June 29, 2015

Reference No. 1528359-2015-072-L-Rev0-1000

**RESPONSE TO MINISTRY OF ENERGY AND MINES MEMORANDUM DATED FEBRUARY 3, 2015,  
REGARDING THE GREENHILLS OPERATIONS TAILINGS STORAGE FACILITY**

Chart 1: Observed Tailings Pond Free Water Volume Over Five Years

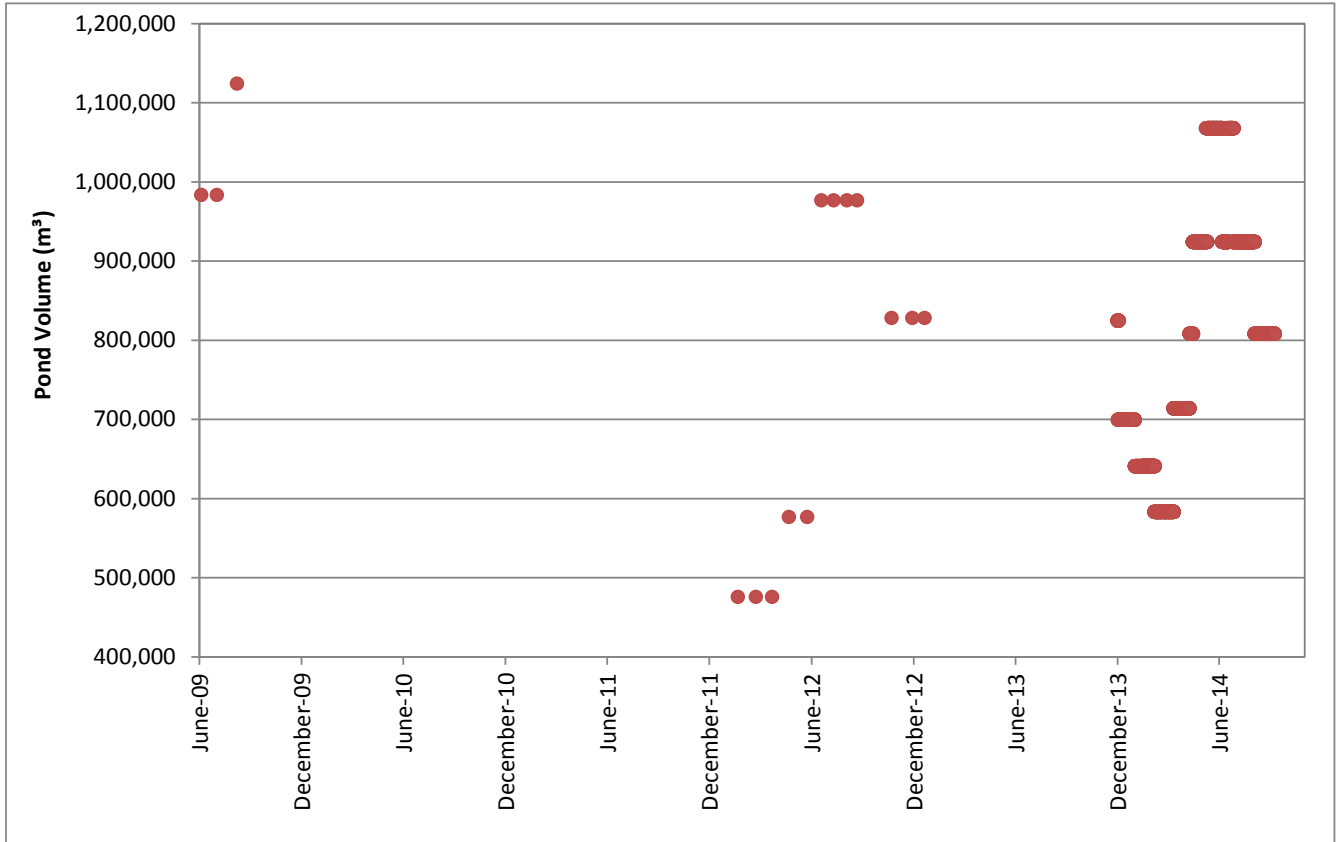
**b) The volume of surplus mine water that has been added to the facility over each of the past five years.**

No surplus mine water has been added to the GHO tailings facility in the last five years.

The estimated total free water in the pond in the last five years (excluding water entrained the pore spaces of the tailings) is shown in Chart 1.

Chart 2: Coarsest and Finest Gradations of Clay Till and Coarse Refuse for Filter Compatibility Comparison

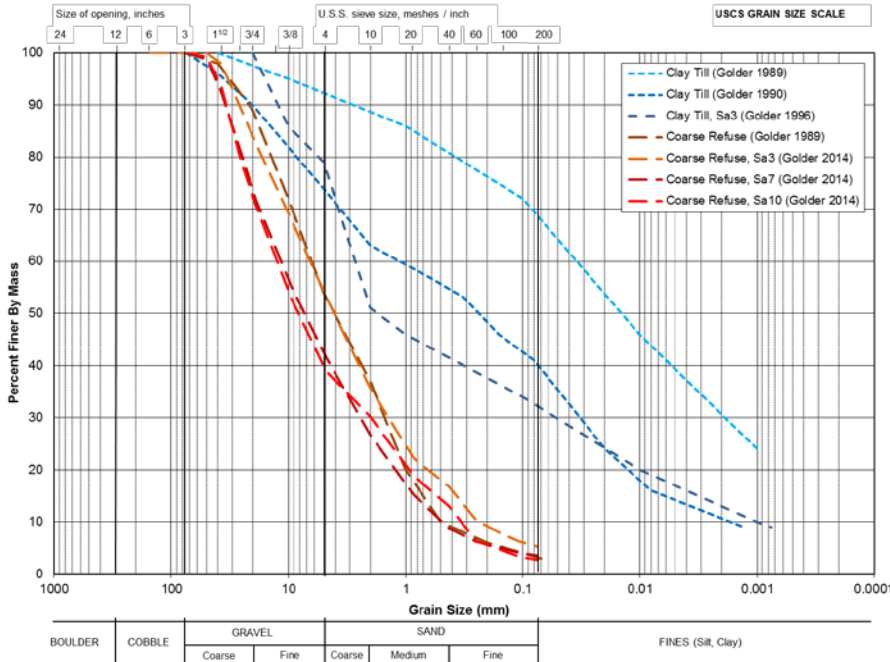
#### b) Whether or not the filter has been constructed in accordance with the design.

The filter compatibility between the clay blanket material and coarse refuse shell material was reviewed based on grain size distributions of 11 clay blanket samples and 13 coarse refuse samples from available construction reports from 1989, 1990, 1992, and 2014 (Golder 1989, 1990, 1992, 2015).

Ten of the 13 coarse refuse (filter) gradations met the filter criteria, with 3 gradations slightly outside of the Sherard criteria ( $D_{15} = 0.85$  mm compared to the criteria of  $D_{15} \leq 0.7$  mm). All samples met the accepted filter criteria in use at the time of the original design.

The internal stability of the coarse refuse filter was assessed based on an update to the original Kenney-Lau criteria by Li and Fannin (Kenney and Lau 1985; Li et al. 2009). The coarse refuse gradations meet the updated Li-Fannin criteria.
